### **SERVICE BULLETIN RELEASE - 07/08/2014**

07-001/14 - 2013-2015 CX-5 - A/C MODE SELECTOR DIAL DOES NOT STAY IN "DEFROSTER VENTS" POSITION - (MANUAL A/C ONLY)

<b>Subject:</b> A/C MODE SELECTOR DIAL DOES NOT STAY IN "DEFROSTER VENTS" POSITION - (MANUAL A/C ONLY)	<b>Bulletin No:</b> 07-001/14
	<b>Last Issued:</b> 07/08/2014

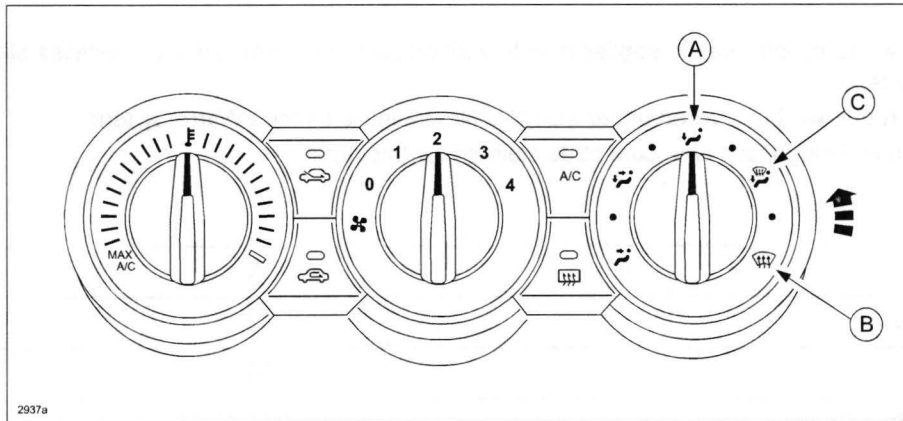
When selecting the "Defroster Vents" position (B) with the Mode Selector Dial (A), some customers may notice the dial does not stay in the "Defroster Vents" position and returns to the "Defroster/Floor Vents" position (C).

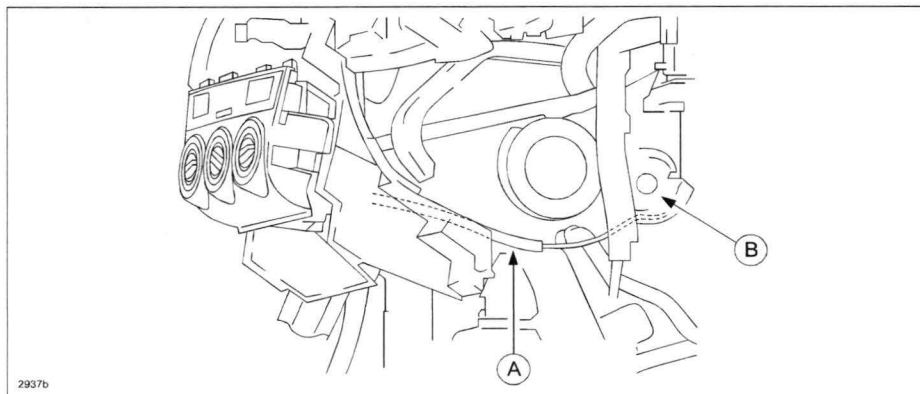
This concern may be due to a production variation. Some of the mode control wires (A) may be too long to transmit movement from the mode selector dial to the link (B). The length of the mode control wire has been shortened to eliminate this concern.

1. Replace the mode control wire with a modified one according to the instructions on MS3 online or the Workshop Manual (section 07-40 CLIMATE CONTROL UNIT REMOVAL/INSTALLATION [MANUAL AIR CONDITIONER])
2. Verify the repair.

Part Number	Description	Qty.	Notes
KD45-61-C35A	Mode Control Wire	1	Manual A/C System
